1852GE–TN01 – Land at Manor Farm, East Grafton

Response to LLFA/SuDS team comments

This drainage note has been prepared for the proposed dwelling on land adjacent to Manor Farm, East Grafton, SN8 3DB. (Application Ref: PL/2026/00800).

Drawing ref. 1852-D01

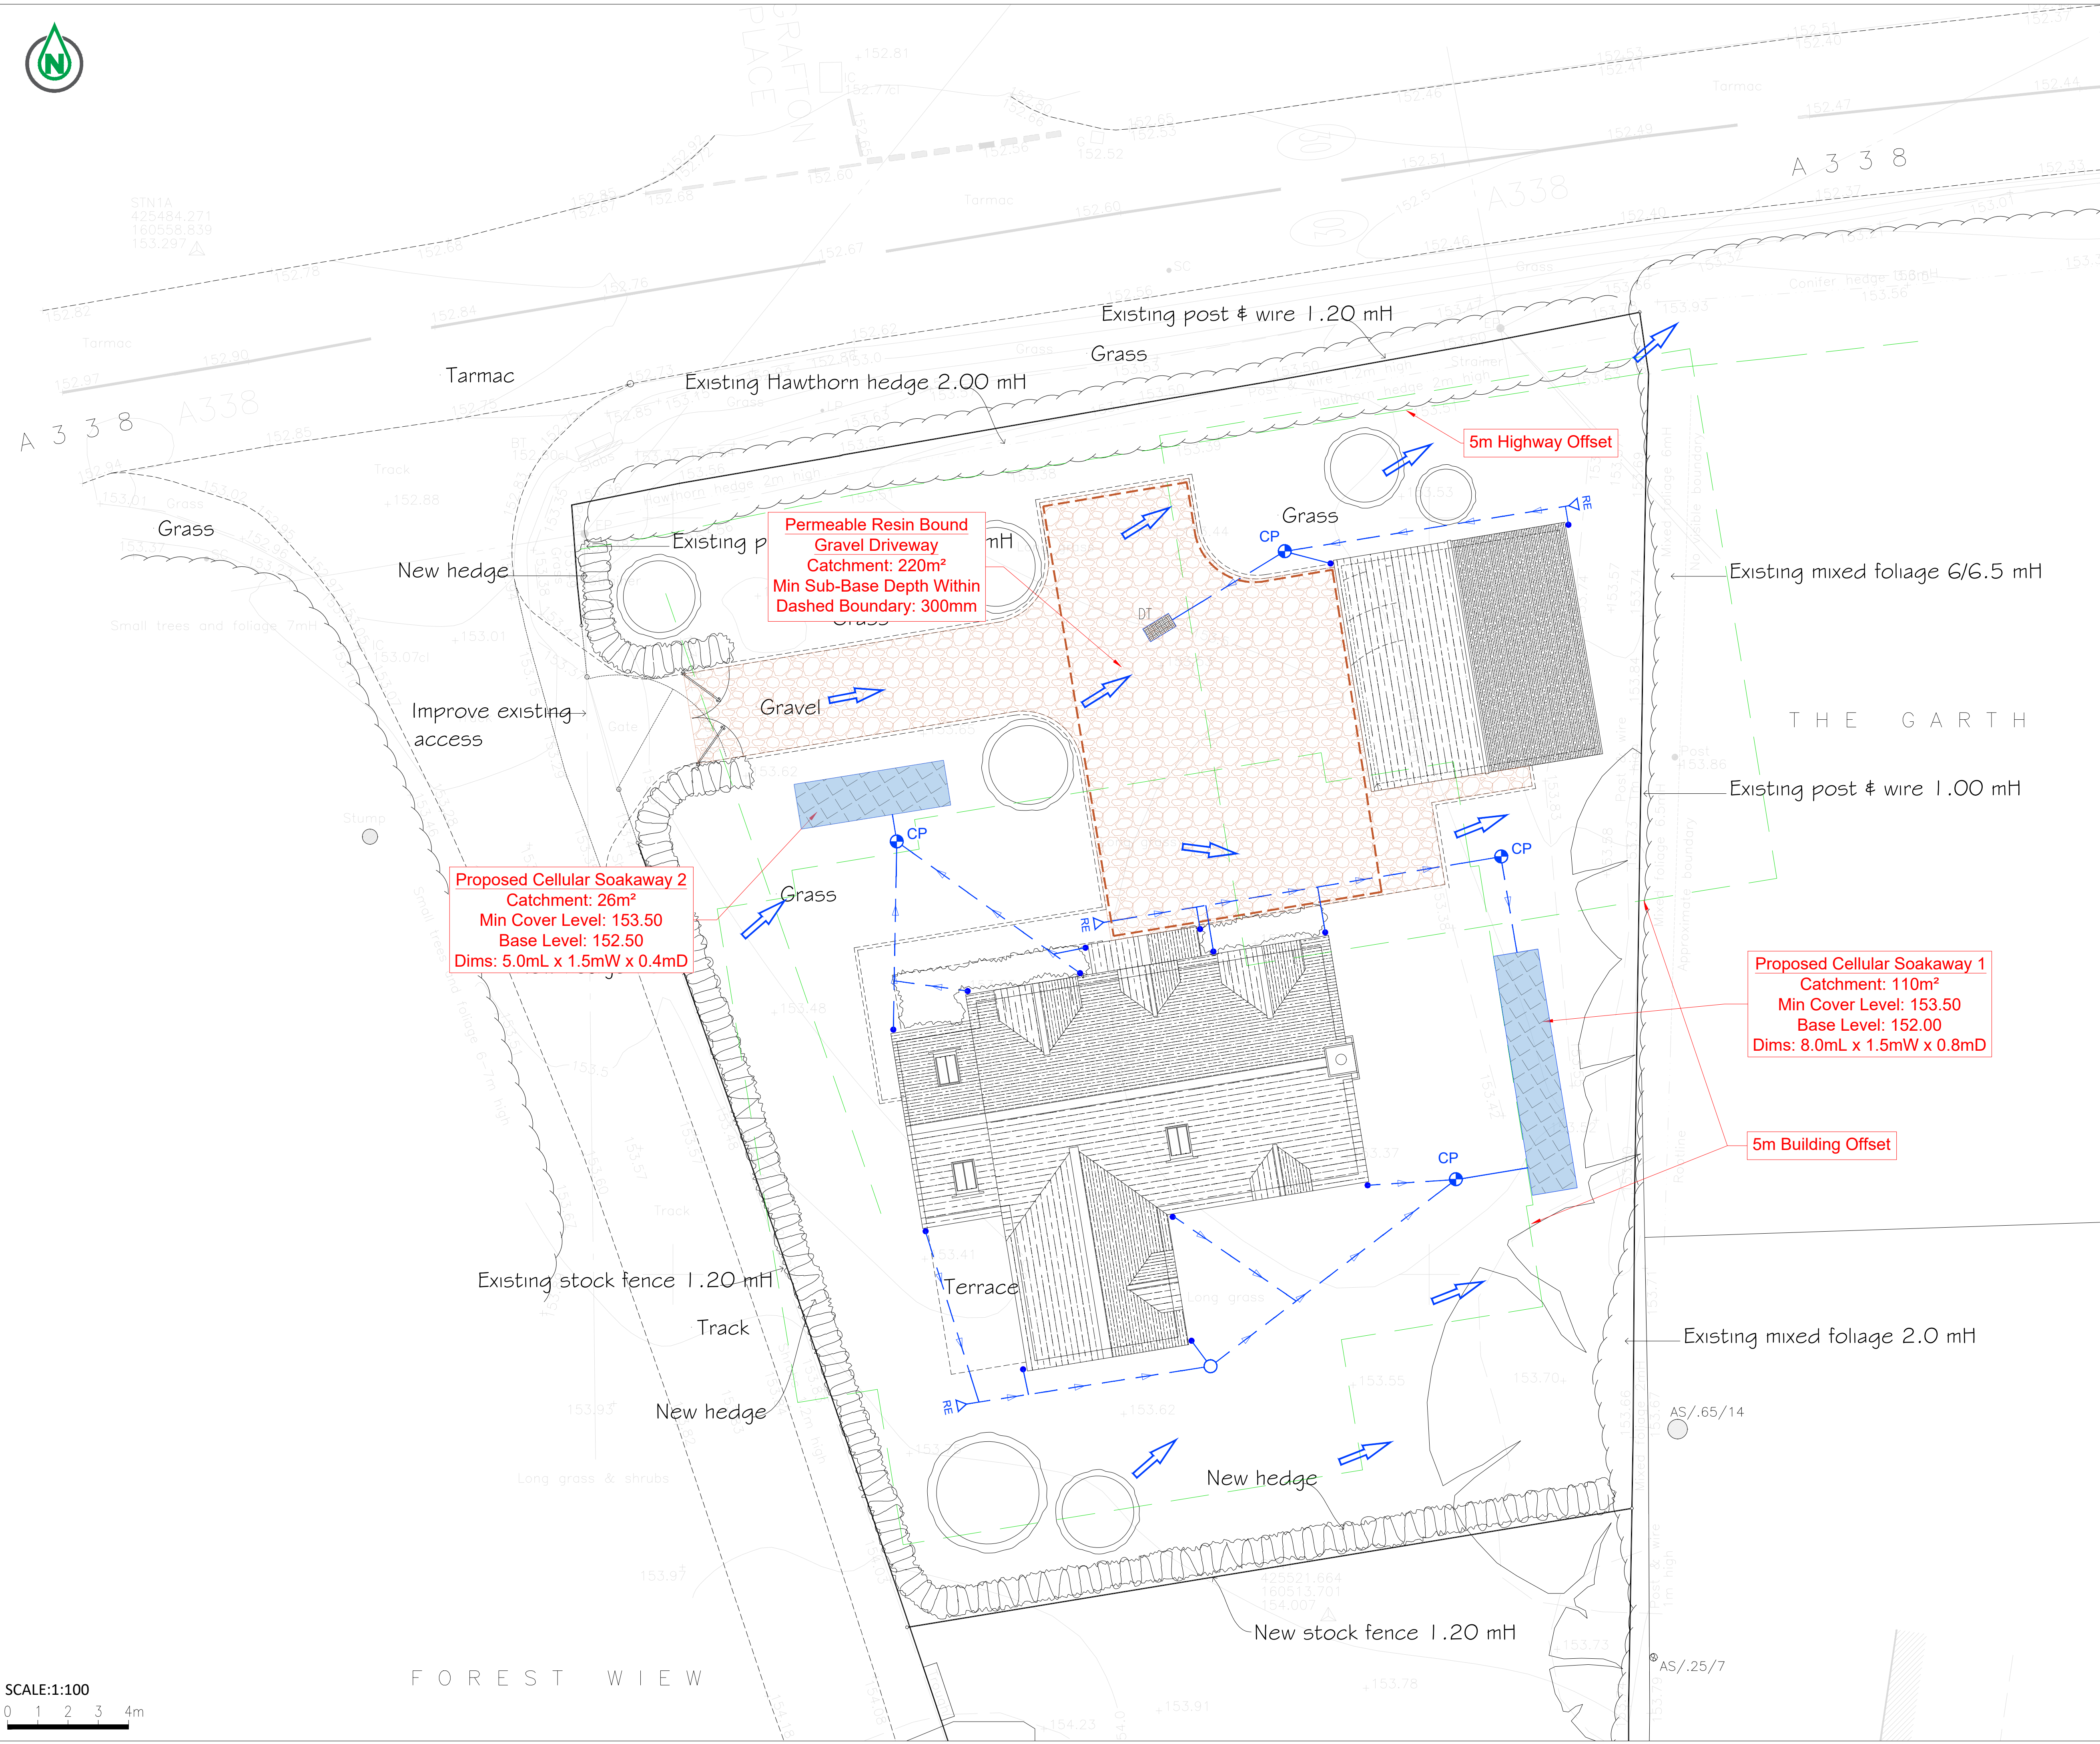
- a) A drainage plan detailing the proposed drainage strategy, including provisions for any access /parking areas.*
- b) The applicant needs to confirm the extent of additional impermeable areas created by the proposed parking spaces and new access and clarify whether these surfaces will be permeable. If they are impermeable, a suitable drainage strategy must be provided to ensure surface water is managed appropriately and does not increase flood risk.*
- c) A plan showing overland exceedance routes that minimise the risk of people and property.*
- d) The applicant shall submit clear arrangements for the ownership and ongoing maintenance of the proposed drainage system (including SuDS features) over the lifetime of the development.*

- f) Evidence that the highest groundwater level (taking into account seasonal variations) has been determined and this is at least 1m below the proposed bottom of the soakaway.
- g) Evidence that soakaways have been sited the appropriate distance from any road in line with CIRIA C574 and Wiltshire Guidance.

- a) Refer to the drawing reference 1852GE-D01 within appendix A of this note. Surface water runoff from the proposed dwelling will drain via cellular soakaways within the garden of the property.  
Runoff from the proposed garage will drain to the permeable resin bound gravel driveway, with a sub-base designed to attenuate and soak away all storm events up to and including the 100yr+45% event.

- b) Overland flow arrows, following the existing topography, demonstrate the surface water flow routes in the event of design exceedance or failure. Exceedance flows will travel northeast over soft landscaping toward the property boundary with the A338, where it would be intercepted by the highway drainage network.

Refer to the drainage plan drawing ref 1852GE-D01 within appendix A, indicating the proposed soakaway offset from the highway and dwelling.
